# NORTHLAND

January 10, 2022, Updated 1.28.22

**RE: McLean Zone 3 Buffer Plan Proposal**

This mark up serves as a response to the correspondence and conversation.

# View 1

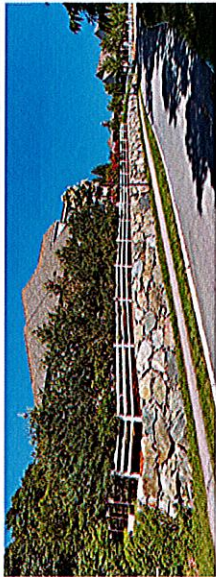
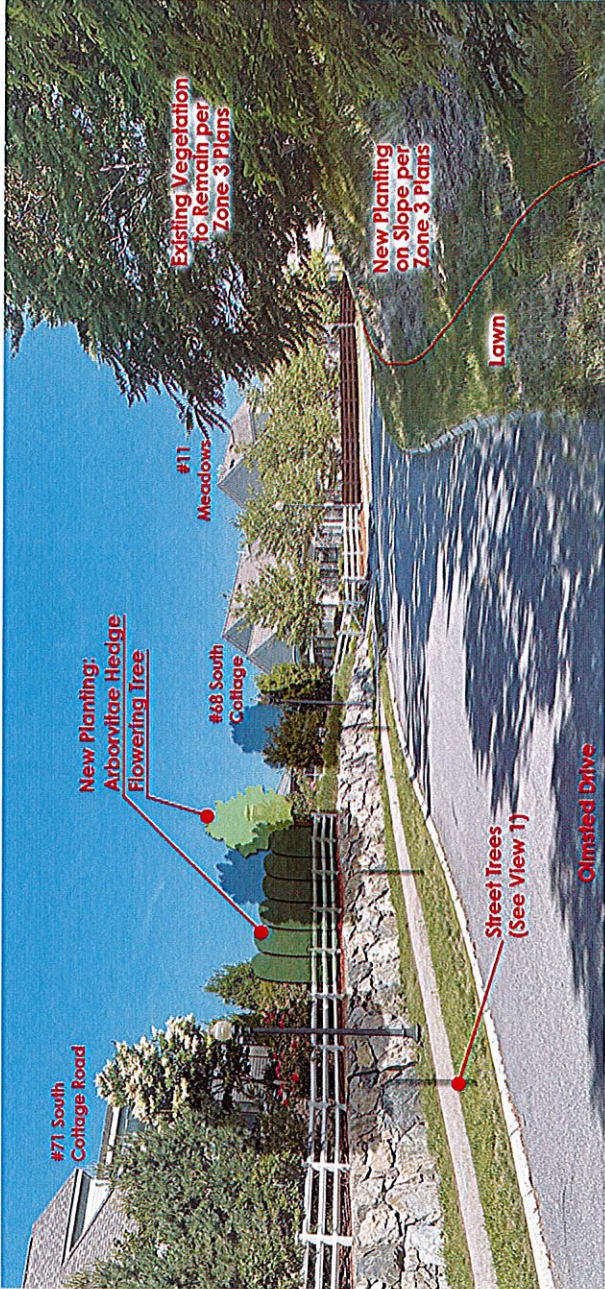
Pursuant to the submitted Design and Site Plan Approval drawings, dated 04/16/21, five street trees, 30' o.c. will be added to the Olmsted Drive parkway strip below #71 South Cottage Road. These five trees are called out as red maples (*Acer rubum*, 3-3.5" caliper). These trees are intended to provide additional screening upgradient and to extend along Olmsted Drive the established row of red maples found there along #68 South Cottage Rd, and #11 Meadows Lane (Area 2). See View #1 below. (all cited views are at end of document)

While the northernmost new street tree will begin to address the northward looking views up Olmsted Drive that the Chens identified as their concern, we also discussed with them the additional planting of 4-6, 6'-8' tall Arborvitaes and a flowering tree to achieve more immediate screening. This evergreen hedge, paired with a flowering tree will have the height and provide the year around interest that the existing roses lack in the critical location. View #2 shows the described additions. The new hedge is planted behind the rail fence with the flowering tree at the northern edge of the front yard. Mrs. Chen also expressed her desire to have the displaced roses transplanted elsewhere in the yard.

Contribute \$4,500 to be used at Trust/Resident discretion for the design, purchase and installation of a plant view screen/hedge at subject unit by Trust/Resident(s).

### View 3 (Area 2)

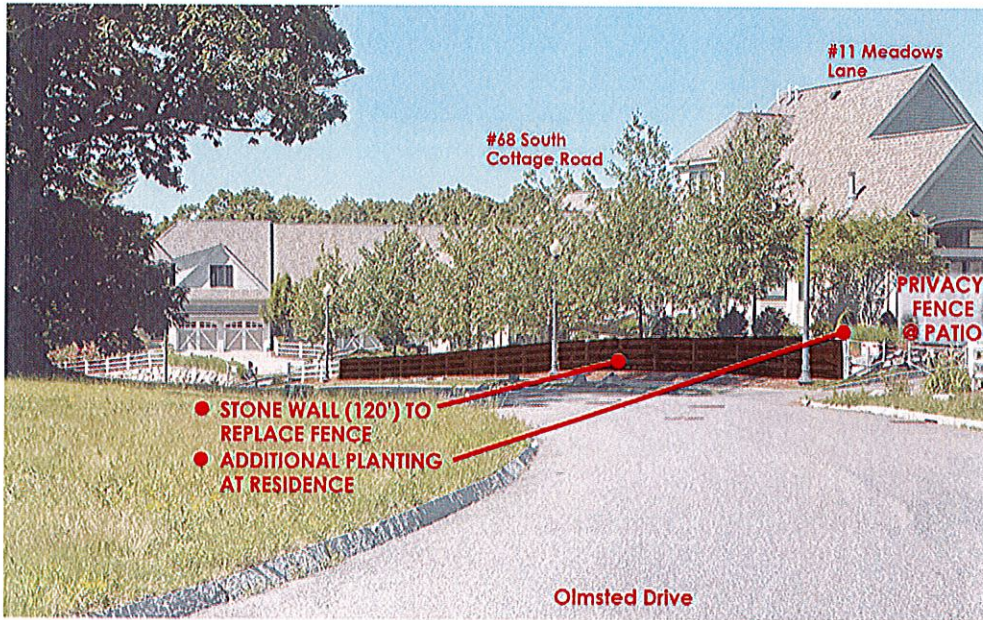
1. **Masonry Wall** - Remove 16 legs, approximately 120 linear feet, of the existing three rail wooden fence located at the Woodland/Zone 3 property line and replace with approximately 120 feet of mortared stone wall measuring 42" in height, 15" in depth, and ~120' in length. Masonry wall to start at the third existing fence post from SCEA Lane and terminate at and by connecting to the existing stone retaining wall paralleling MLEA Lane – the existing MLEA wall and proposed masonry wall will connect. The existing rubble wall east of the Rome patio will be removed and graded into the proposed masonry wall. Barring any siting conflicts, the wall layout to be on-center with the existing fence and shall follow the arc of the sidewalk. Masonry wall work to be performed by Northland and to be of a kind and quality in keeping with the mortared stone walls at South Cottage of the Woodlands and/or the retaining wall along Olmsted Drive in Zone 3 below the Samuel Eliot Memorial Chapel.

4. **Ownership and Maintenance** – the proposed masonry wall shall be owned and maintained by Zone 3.
2. **Patio Privacy Screen** –At Eckert (68 SC) and Rome (11 ML) patios: privacy fence panels with lattice or other 'topper' along the side-length of the patio paralleling Olmsted Drive. Northland to Contribute \$10,000 to be used at Trust/Resident(s) discretion for the design, purchase and installation of Patio Privacy Screen by Trust/Resident(s).

3. **Buffer Planting** – Northland to Contribute \$30,000 to be used at Trust/Resident discretion for the modification or augmentation of existing planting beds at 68 SC and 11 ML paralleling Olmsted Drive. Work to be performed by Trust/Resident(s).
